Jenkintown Borough Planning Commission meeting minutes for June 18, 2024

Sub-Division Land Development Application– Jenkins Court Realty Company, 610 York Road - Coffee Shop and Frozen Dessert establishments

Re: MCPC #24-0086-001
Plan Name: Starbucks and Dessert Shop
(1 lot/3,522 sq. ft. commercial on approximately 7.9 acres)
Situat: Old York Road (E); south of Rodman Avenue
Jenkintown Borough

**RE: 610 Old York Road
Preliminary Land Development Plan Review (2nd Submission)
Borough of Jenkintown, PA**

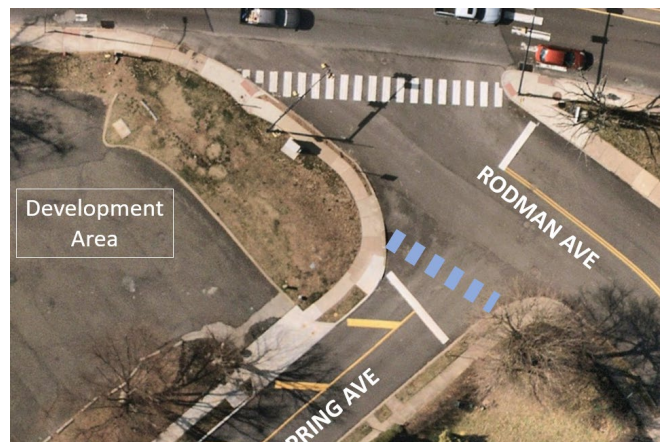
- F. Landscape Buffer. As noted on Sheet 13, a Class C buffer is required by §160-31.B. between the proposed commercial development and the existing residential area along Spring Avenue, and where the property abuts the side property line of a residential property on the west side of Spring Avenue. The required 10-foot buffer width should be dimensioned on the site plan and the appropriate amount of landscaping should be shown on the landscape plan.

Figure 5 of the borough’s subdivision and land development ordinance provides several options for a Class C buffer and a note on Figure 5 states that “a Class C buffer must be adequate to visually screen the proposed land use or development from off-site view” and that “grading treatments and architectural features; such as walls and/or fences may be required in addition to the minimum planting quantities in order to provide effective visual screening.” A fence is proposed in the vicinity of the pick-up window for the drive-through lane; however, the applicant may wish to consider whether additional berming and/or fencing could be incorporated to provide additional visual screening within the full buffer length.
